NPF-10/15/413

ATTACHMENT A
PROPOSED SPECIFICATION
UNIT 2

3/4.7.3.1 COMPONENT COOLING WATER SAFETY RELATED MAKEUP SYSTEM

ATTACHMENT B
PROPOSED SPECIFICATION
UNIT 3

Figure 3.7-2

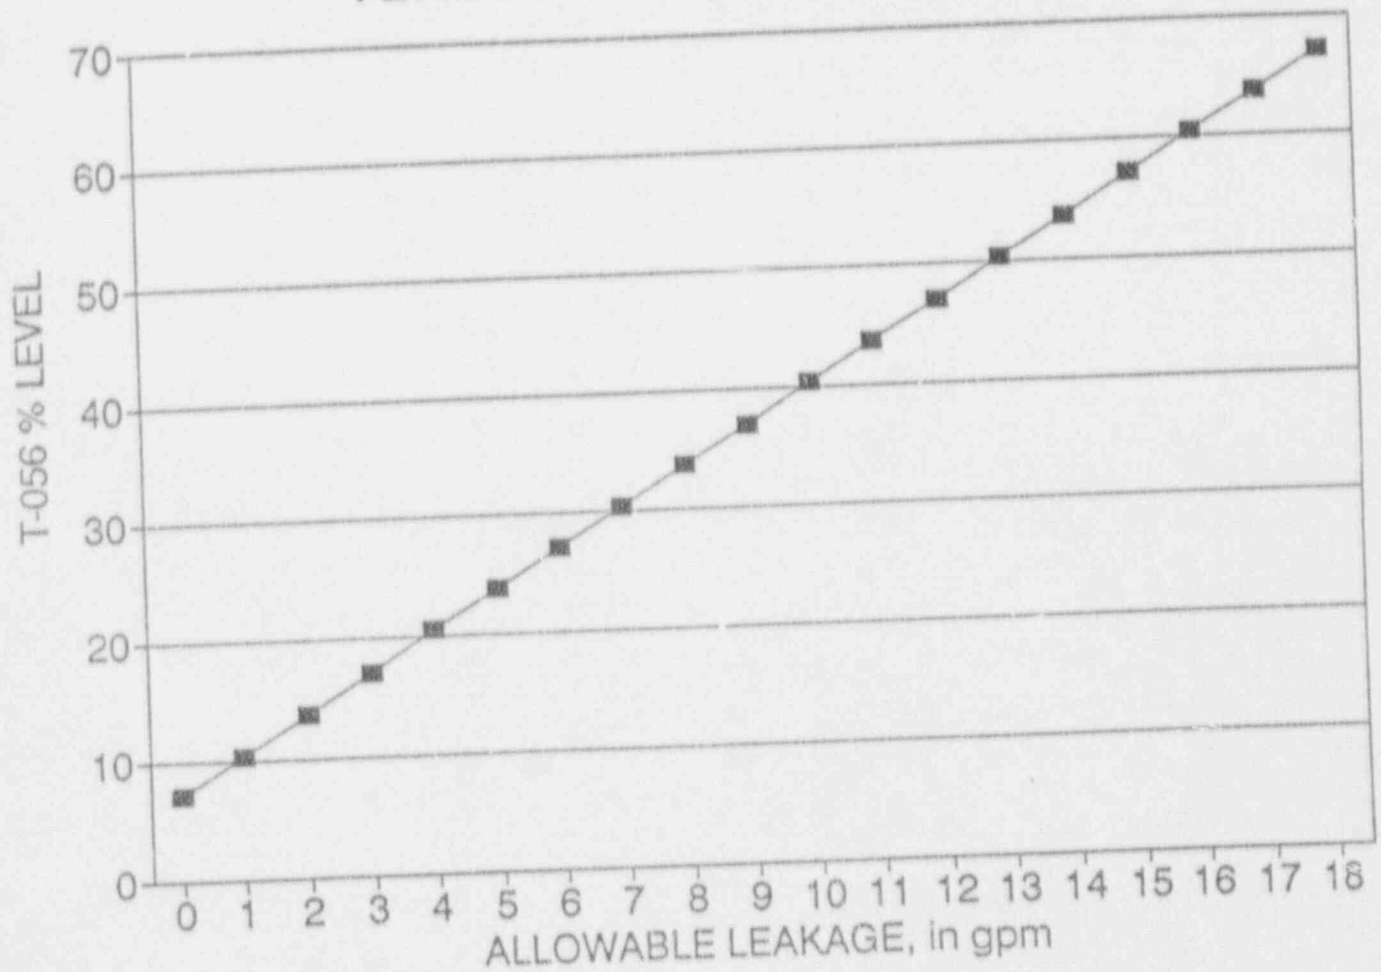
3.7.3.1 Two trains of Component Cooling Water (CCW) Safety Related Makeup System shall be OPERABLE with a contained volume in the Primary Plant Makeup Storage Tank at or above the level specified in Figure 3.7-2.

- a. With one CCW Safety Related Makeup flow path inoperable, restore the flow path to OPERABLE status within 7 days.
- b. With the Primary Plant Makeup Storage Tank level less than that required by Figure 3.7-2, and/or both CCW Safety Related Makeup flow paths inoperable, restore the Primary Plant Makeup Storage Tank level and one CCW Safety Related Makeup flow path to OPERABLE status within 8 hours.
- c. With Actions a or b, above, not completed in the specified action times, be in HOT STANDBY within the next 6 hours, and be in COLD SHUTDOWN within the following 24 hours.
- d. The provisions of Specification 3.0.4 are not applicable.

For any point on the curve in Figure 3.7-2, the required water level is based on the associated leak rate from the CCW system, an unrecoverable volume and a level instrumentation Total Loop Uncertainty (TLU). For example, a leak rate of 18 gpm for seven days corresponds to a volume of 181,440 gallons. If the TLU and the unrecoverable volume are added to this, the total is 203,100 gallons. Dividing this number by the total tank volume of 303,500 gallons yields 67%.

Figure 3.7-2

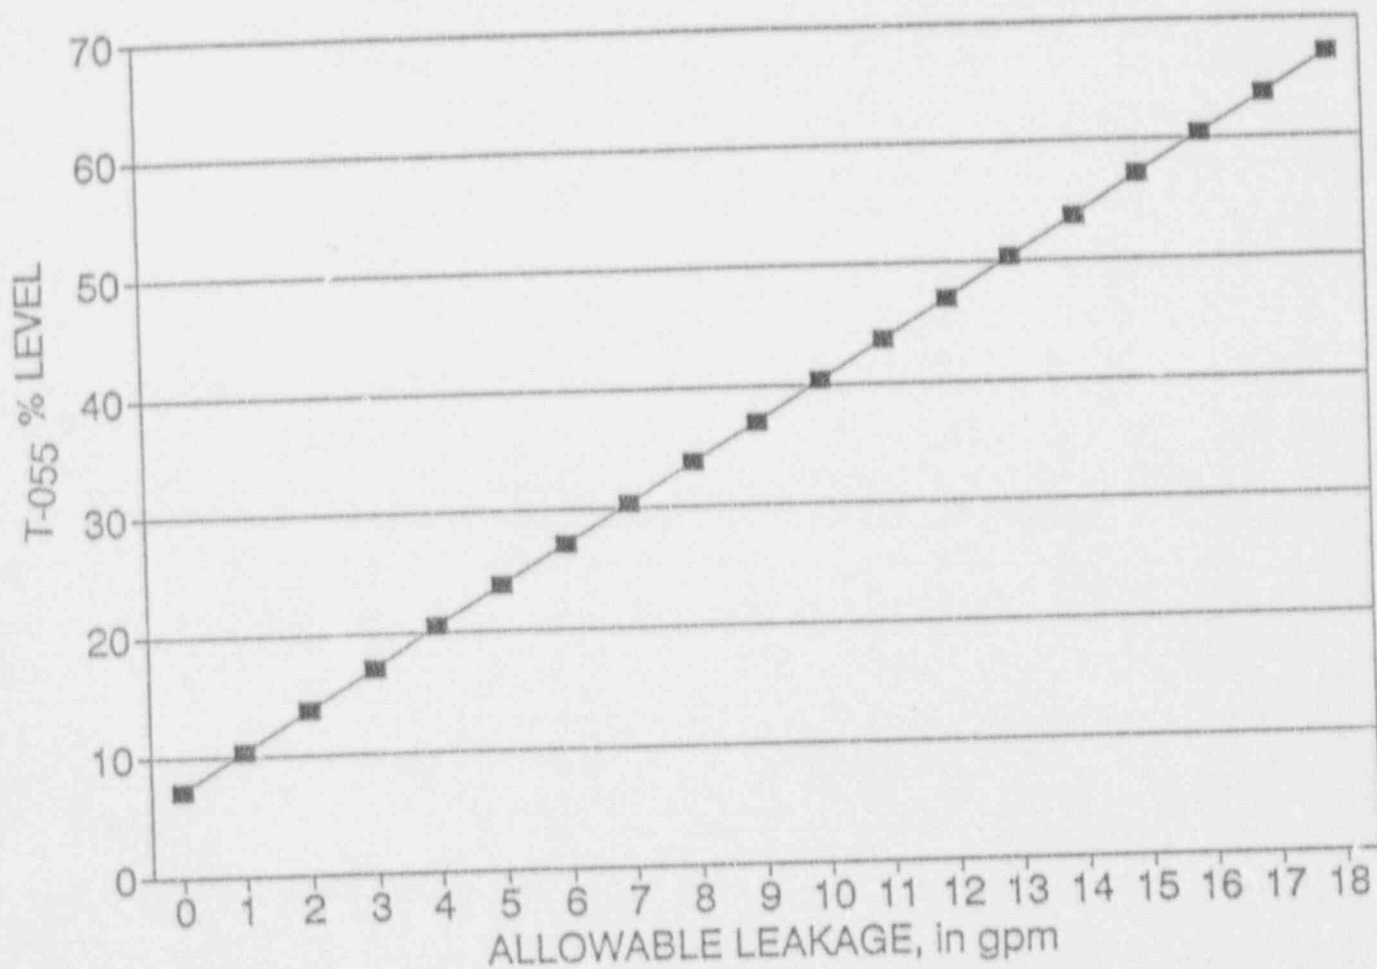
3.7.3.1 Two trains of Component Cooling Water (CCW) Safety Related Makeup System shall be OPERABLE with a contained volume in the Primary Plant Makeup Storage Tank at or above the level specified in Figure 3.7-2.

- a. With one CCW Safety Related Makeup flow path inoperable, restore the flow path to OPERABLE status within 7 days.
- b. With the Primary Plant Makeup Storage Tank level less than that required by Figure 3.7-2, and/or both CCW Safety Related Makeup flow paths inoperable, restore the Primary Plant Makeup Storage Tank level and one CCW Safety Related Makeup flow path to OPERABLE status within 8 hours.
- c. With Actions a or b, above, not completed in the specified action times, be in HOT STANDBY within the next 6 hours, and be in COLD SHUTDOWN within the following 24 hours.
- d. The provisions of Specification 3.0.4 are not applicable.

For any point on the curve in Figure 3.7-2, the required water level is based on the associated leak rate from the CCW system, an unrecoverable volume and a level instrumentation Total Loop Uncertainty (TLU). For example, a leak rate of 18 gpm for seven days corresponds to a volume of 181,440 gallons. If the TLU and the unrecoverable volume are added to this, the total is 203,100 gallons. Dividing this number by the total tank volume of 303,500 gallons yields 67%.
